DOCKET ITEM #13
Development Special Use Permit #2015-0008
Transportation Management Plan SUP #2015-0045
2200-A Mill Road – Eisenhower East Block 20

Purpose of Application
Approval of a three year extension for a previously approved Development Special Use Permit, DSUP #2012-0003 for Block 20 in the Eisenhower East Small Area Plan area

Figure 1020.1.6.2 Example Building Footprint Sign

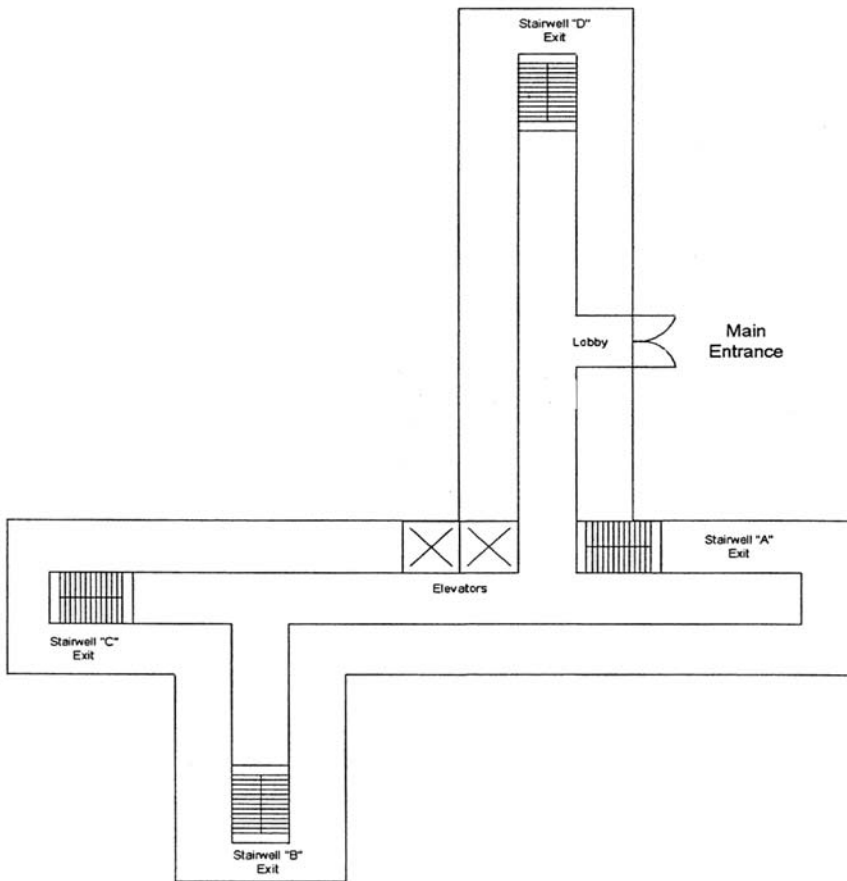
Footprint requirements. In buildings greater than three stories where there is no graphic representation of the building footprint, a simplified building schematic must be display in the lobby. The simplified building footprint shall be an overhead view of the buildings exterior and the general layout of the lobby of the first floor. Stairways shall be denoted by letter as stated in section 1020.1.6. (See Figure 1020.1.6.2)

Figure 1020.1.6.2 Example Building Footprint Sign

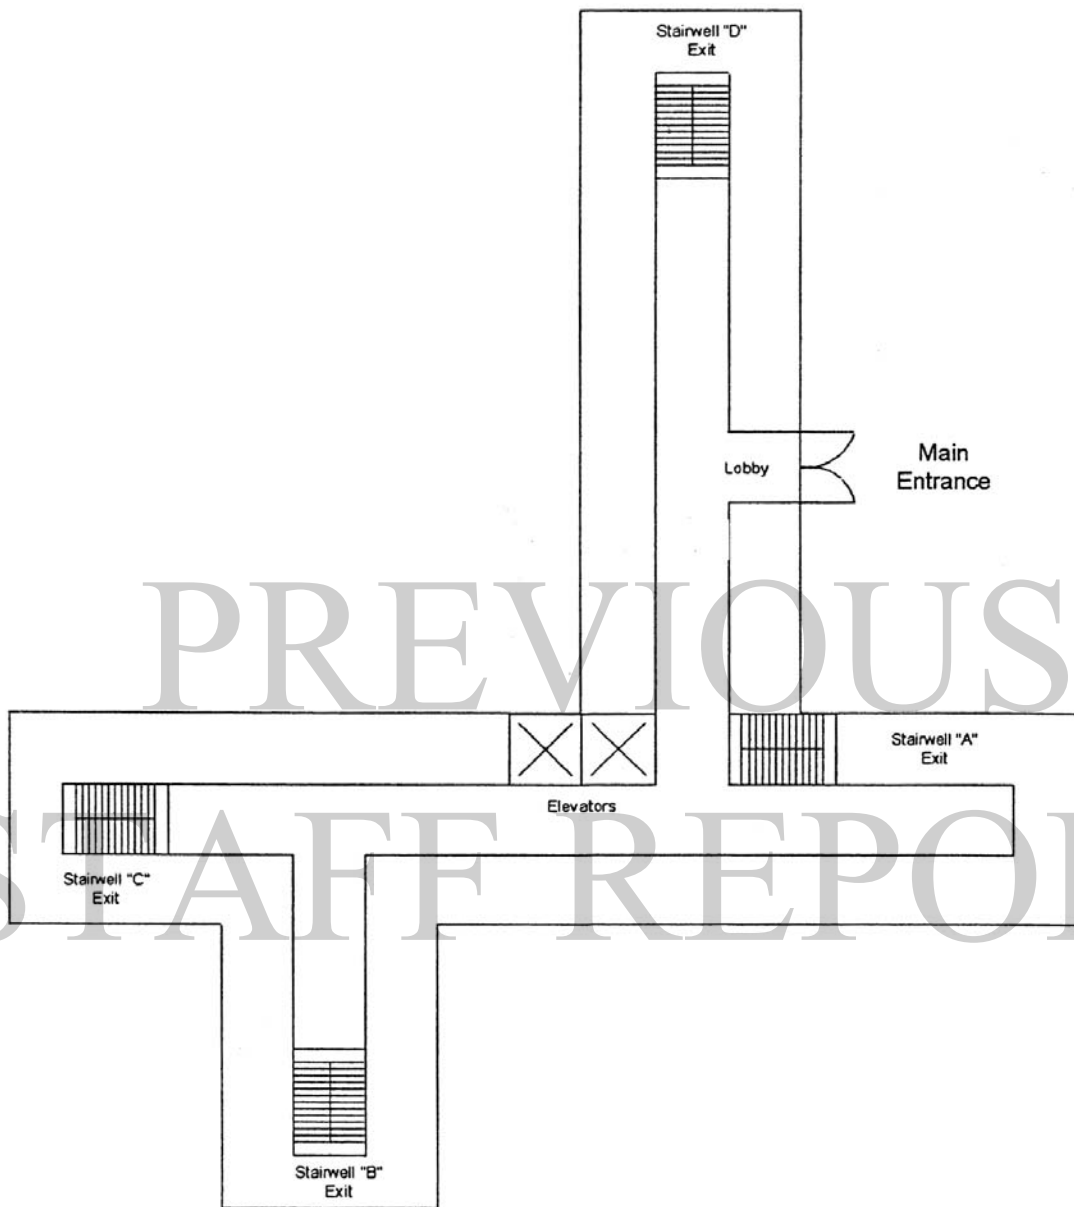
C -9 Provide Stairway Identification. A sign shall be provided at each floor landing in interior vertical exit enclosures connecting more than three stories designating the floor level, the terminus of the top and bottom of the stair enclosure and the identification of the stair. The signage shall also state the story of, and the direction to the exit discharge and the availability of roof access from the stairway for the fire Department, in accordance with USBC 1020.1.6. and the City Fire Prevention Code. Building footprint map is not required if graphic annunciator is installed.

simplified building footprint shall be an overhead view of the buildings exterior and the general layout of the lobby of the first floor. Stairways shall be denoted by letter as stated in section 1020.1.6. (See Figure 1020.1.6.2)

Emergency Vehicle Easements

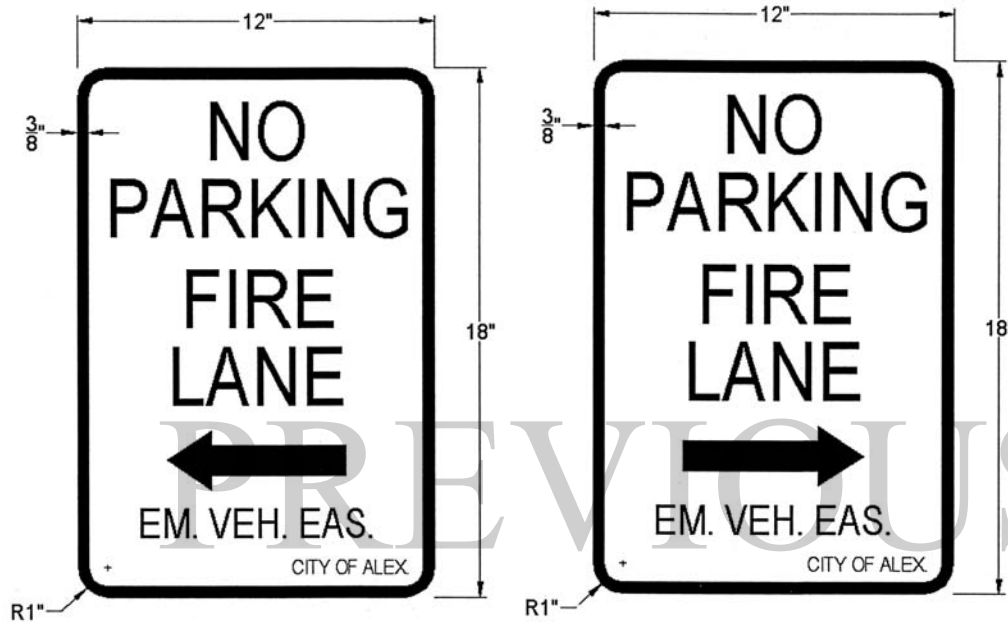
- C-7 The final site plans shall show placement of emergency vehicle easement signs. See sign detail and placement requirements below.

Figure 1020.1.6.2 Example Building Footprint Sign

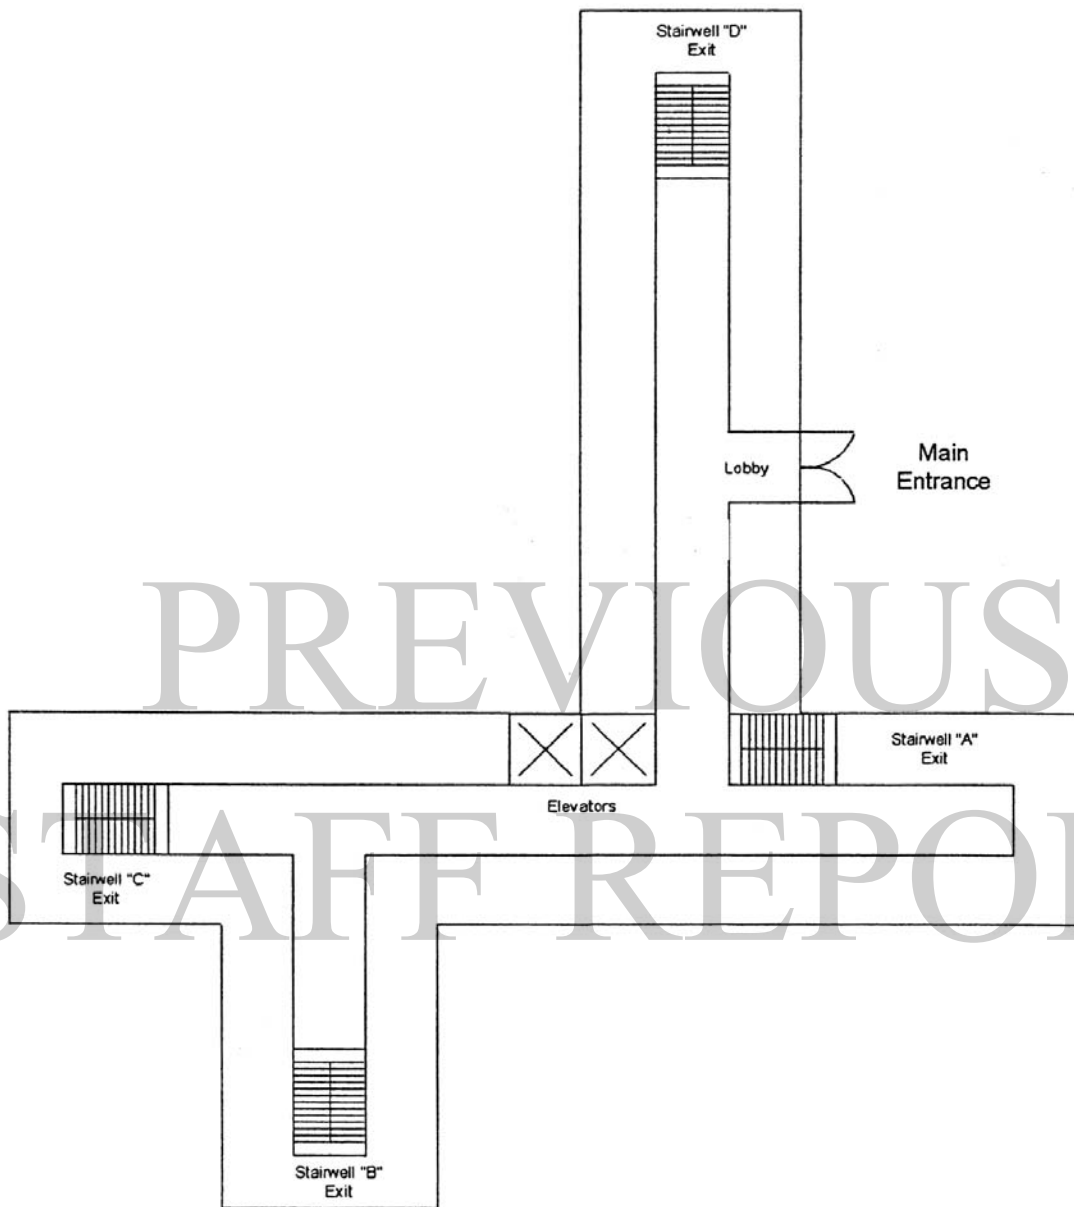
C-9 Provide Stairway Identification. A sign shall be provided at each floor landing in interior vertical exit enclosures connecting more than three stories designating the floor level, the terminus of the top and bottom of the stair enclosure and the identification of the stair. The signage shall also state the story of, and the direction to the exit discharge and the availability of roof access from the stairway for the fire Department, in accordance with USBC 1020.1.6. and the City Fire Prevention Code. Building footprint map is not required if graphic annunciator is installed.

simplified building footprint shall be an overhead view of the buildings exterior and the general layout of the lobby of the first floor. Stairways shall be denoted by letter as stated in section 1020.1.6. (See Figure 1020.1.6.2)
